Access Compliance Report Public Rights-of-Way (Curb Ramps)

Main Street: BEACH_BLVD Cross Street: LEGION_PL Location: NE

ADA ID: RPRK220202121945 Ramp Type: Type 4 - Parallel Initial Pass/Fail: Pass Overall Compliance: No Severity Score: 0

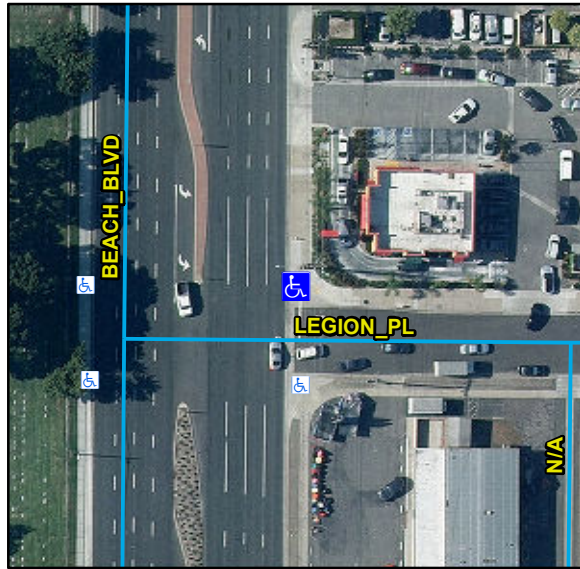
N/A	Ramp Inside Crosswalk 1	N/A	N/A	Ramp Inside Crosswalk 2	N/A
	Crossing 1 Slope (%)	4.9		Crossing 2 Slope (%)	3.1
	Crossing 1 Cross Slope (%)	0.5		Crossing 2 Cross Slope (%)	3.2
Yes	Gutter Ponding	No	No	Curb Slope	9.1
Yes	Gutter Lip Height (in)	0		Road Run Slope (%)	1
Yes	Gutter Run Slope (%)	2.6		Road Cross Slope (%)	0.4
Yes	Gutter Cross Slope (%)	1.5	Yes	Perpendicular Joint Present	Yes
Yes	Overall Surface Condition	Acceptable			
	Cross Gutter Present?	Yes		Spandrel Present?	Yes
	Replace Cross Gutter?	No		Replace Spandrel?	No

Remove & Replace Curb Slope.

R304.2.2, STD 1115
